R07MS

January 16, 2008

Service Bulletin 34273

Instructions for Braun Corporation "Public and Private Use" Dual Parallel Arm Lift Threshold Sensitivity Evaluation and NHTSA Compliance Applicable for NL, NCL and NVL Series Lifts

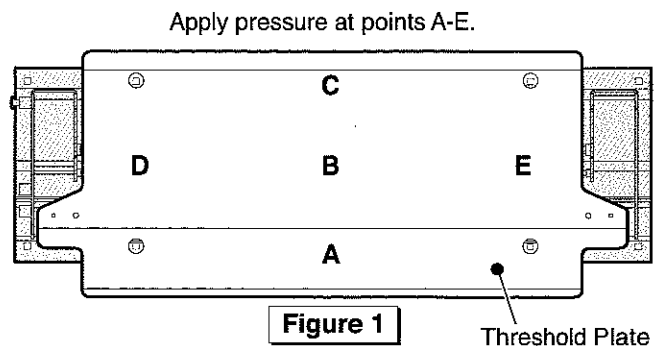
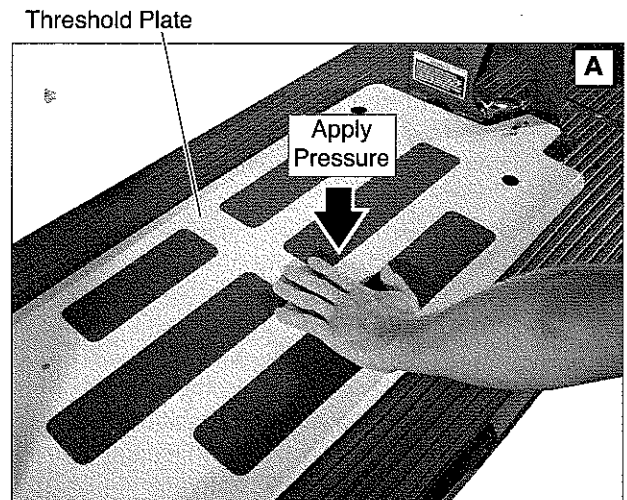
1. Turn Lift Power switch ON. Deploy the lift platform fully to the ground.
2. Apply hand pressure on the center of the threshold plate as shown in Photo A. The visual and/or audible threshold warning* should be activated when you push down.

Repeat the sensitivity test procedure at positions A-E shown in Figure 1.

3. If the threshold alarm is activated at all positions, no further procedures are required. The lift threshold sensitivity meets NHTSA FMVSS 403/404 requirements.

If the threshold alarm is not activated at all positions, perform the retrofit procedures detailed on pages 2 and 3 of this bulletin. Repeat the sensitivity test procedures following the retrofit. If the lift still does not meet the requirement, contact a Braun Corporation Product Support representative at 1-800-THE LIFT®.

D

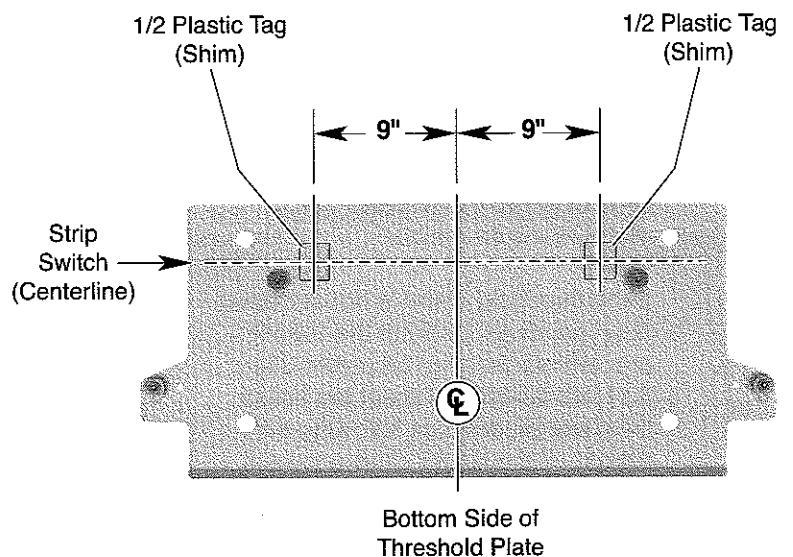
Turn threshold plate over. See Photo D. The strip switches typically leave an impression (mark) on the yellow plate from use. Use the impression of the inboard strip switch as a centerline for shim positioning (or measure to establish position).

Position each shim 9" from the center of the threshold plate (see Photo D). Align the tags with the strip switch centerline. Clean the surface as detailed below and affix the adhesive-backed tag to the plate (**press firmly**).

Note: Clean the surface with isopropyl alcohol before affixing the tag. Use a clean cloth or paper towels. Do not use oily shop rags. Wipe surface free of residue with dry portion of cleaning cloth.

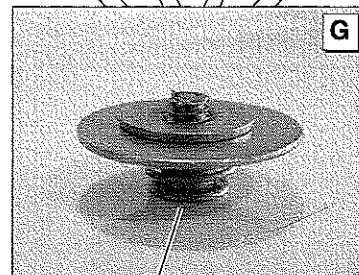
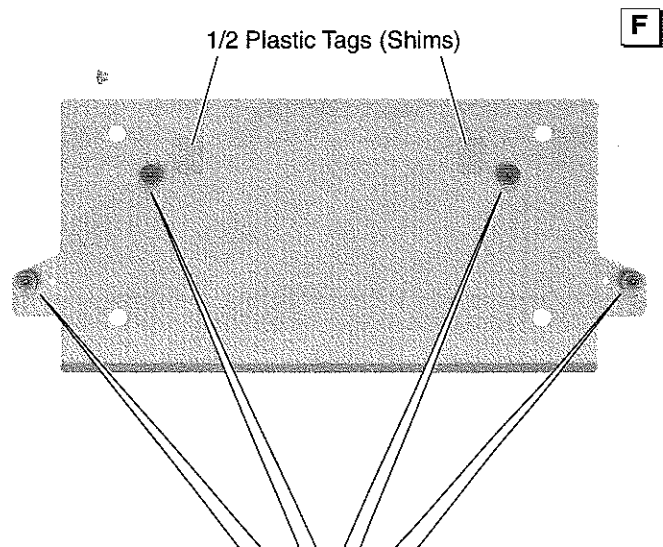
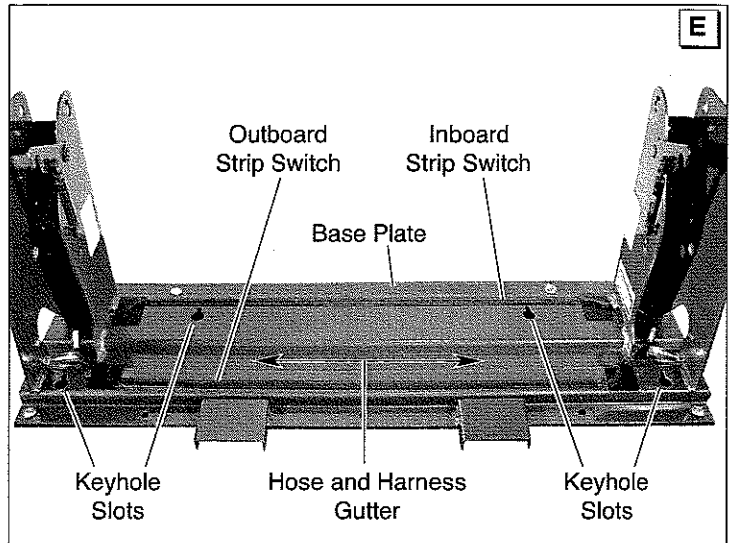
4. Reposition the threshold plate (with shim). Align the keeper standoffs (studs) on the bottom of the threshold plate with the base plate keyhole slots. See Photos E, F and G. Insert studs and **carefully** slide the plate inward (engage slots fully).

Ensure all hoses and wiring harnesses routed through the base plate gutter are positioned fully in the gutter and not located anywhere they could potentially interfere with activation of the tape switches. See Photo E.

Note: Spraying a light mist of glass cleaner (or other) to the strip switches will aid in the plate sliding easier into position. See Photos E, F and G.

Ensure all four keeper standoffs engage the base plate keyhole slots.
